## STAFF REPORT COMMUNITY DEVELOPMENT DEPARTMENT

SUBJECT: H-2020-0077  
Hill's Century Farm North No. 2

Final plat consisting of 134 buildable lots and 18 common lots on 29.77 acres of land in the R-8 and R-15 zoning districts.

A. Preliminary Plat (dated: 11/18/2019)

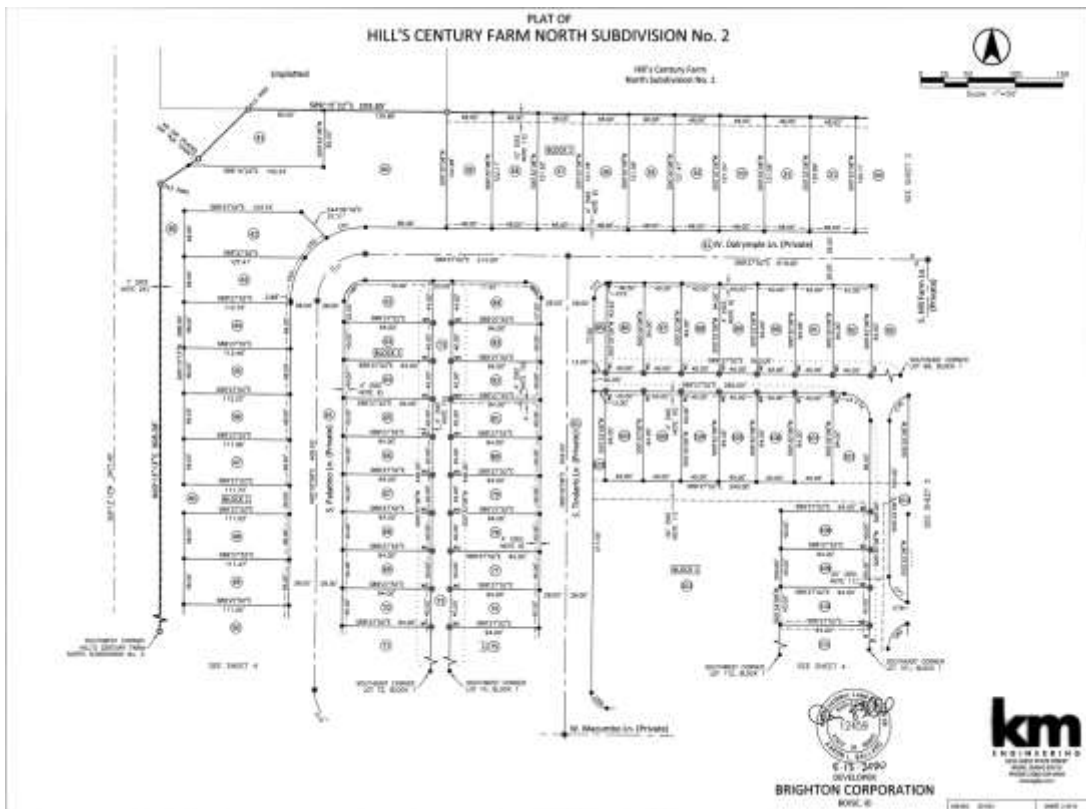
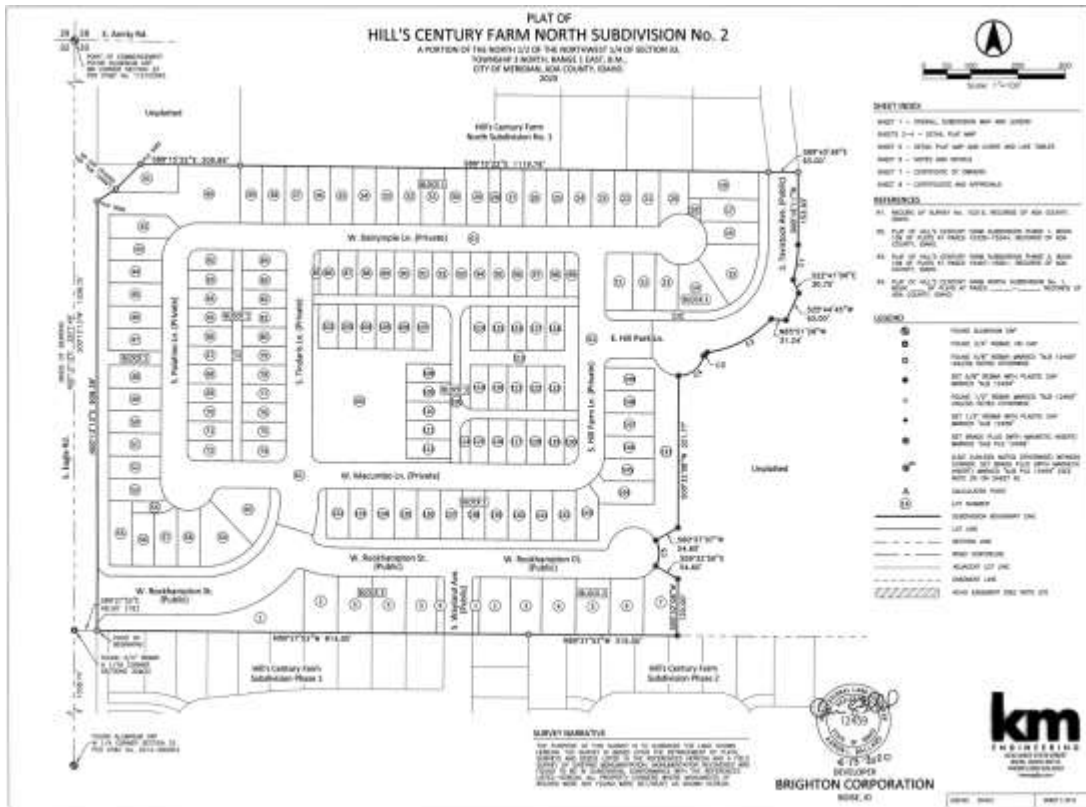
Staff has reviewed the proposed final plat for substantial compliance with the approved preliminary plat (H-2019-0134) in accord with the requirements listed in UDC 11-6B-3C.2.

In order for the proposed final plat to be deemed in substantial compliance with the approved preliminary plat as set forth in UDC 11-6B-3C.2, the number of buildable lots cannot increase and the amount of common area cannot decrease. Staff has reviewed the proposed plat and the number of buildable lots and common open space in this phase are the same as depicted on the approved

preliminary plat; therefore, Staff deems the proposed final plat to be in substantial compliance with the approved preliminary plat as required.

B. Final Plat (dated: 5/13/20)

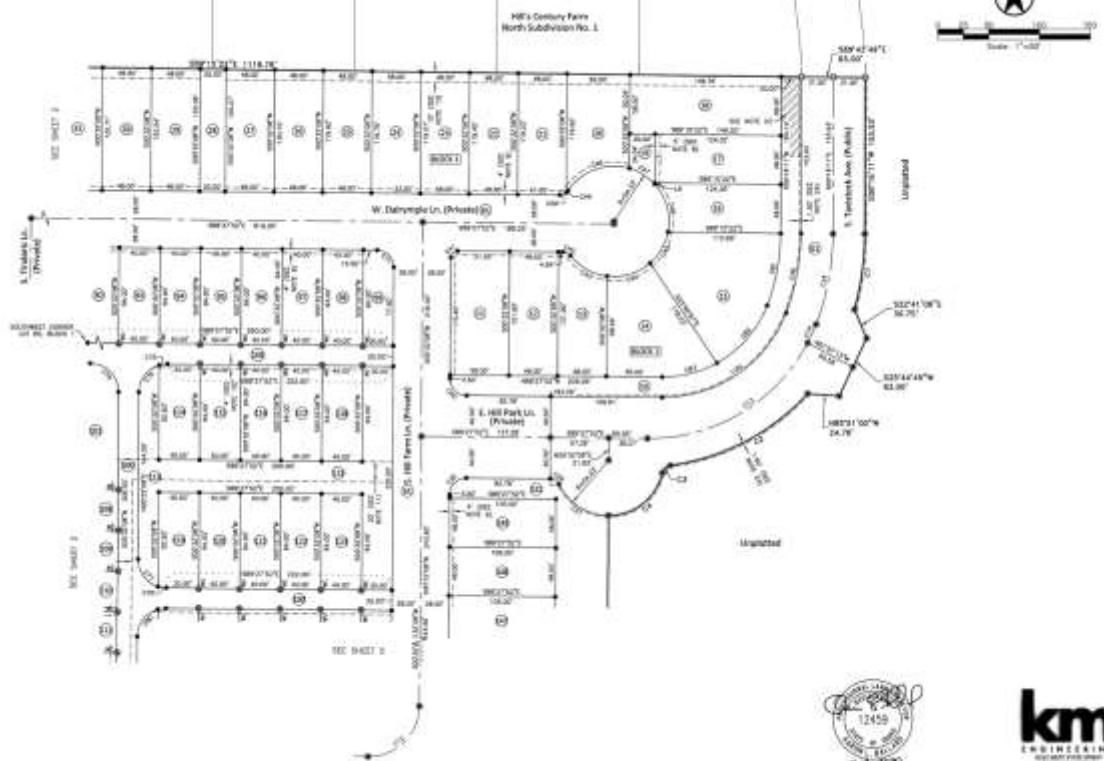
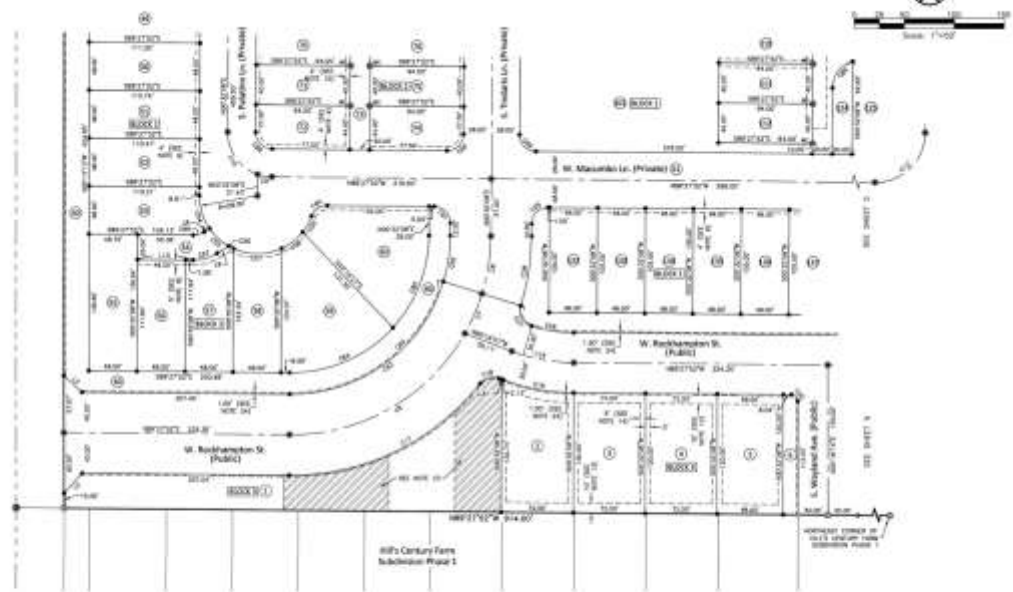
3. Prior to submittal for the City Engineer's signature, have the Certificate of Owners and the accompanying acknowledgement signed and notarized.
4. The final plat prepared by KM Engineering, stamped by Aaron L. Ballard, dated: 5/13/2020, included in Section V.B shall be revised as follows:

- a. Note #1: "Minimum building setback lines shall conform to ~~the~~ that approved with the planned unit development (H-2019-0134) or the applicable zoning regulations of the City of Meridian at the time of issuance of a building permit, as applicable."

- b. Note #9: Correct the typo on the width of the easement.
  - c. Note #11: Include the recorded instrument number of the City of Meridian sewer and water easement.

- d. Note #19: Include the recorded instrument number of the ACHD landscape license agreement easement.
  - e. Note #24: Include the recorded instrument number of the ACHD public right-of-way easement.

- f. References – R4.: Include the Book and Page numbers of the recorded plat for phase 1.  
*A copy of the revised plat shall be submitted with the final plat for City Engineer signature.*

## D. Common Driveway Exhibit

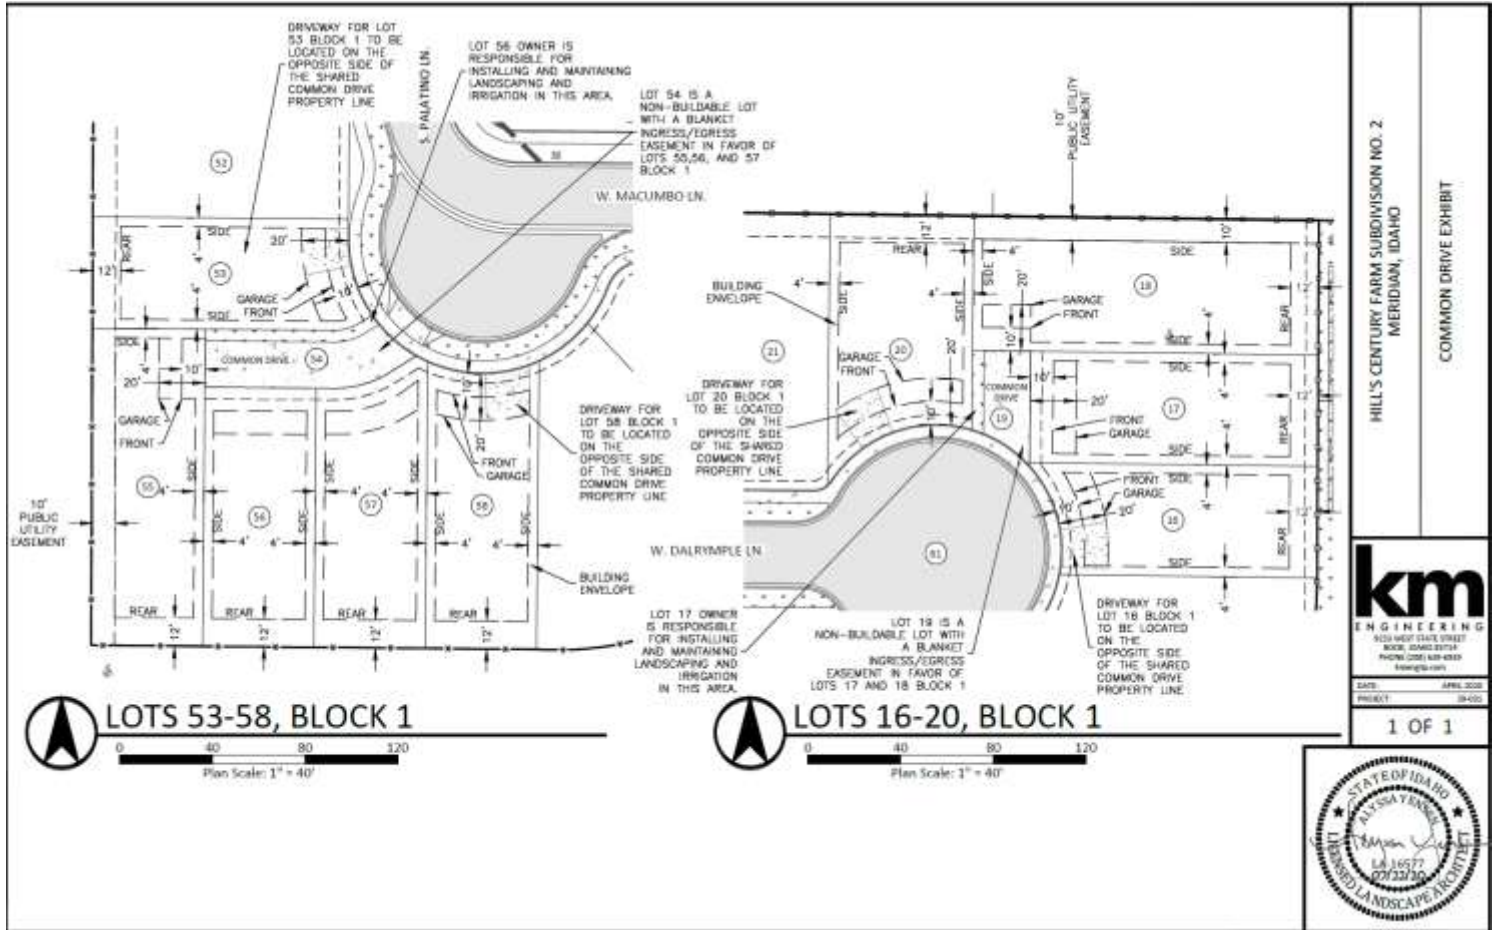
13. Address signage shall be provided at the ends of the common driveways on Lots 19 and 54, Block 1; and for lots accessed by alleys that don't have frontage on a private street for emergency wayfinding purposes.

14. All common driveways shall comply with the standards listed in UDC 11-6C-3D; homes on lots accessed via common driveways shall comply with the setbacks shown on the exhibit in Section V.E.
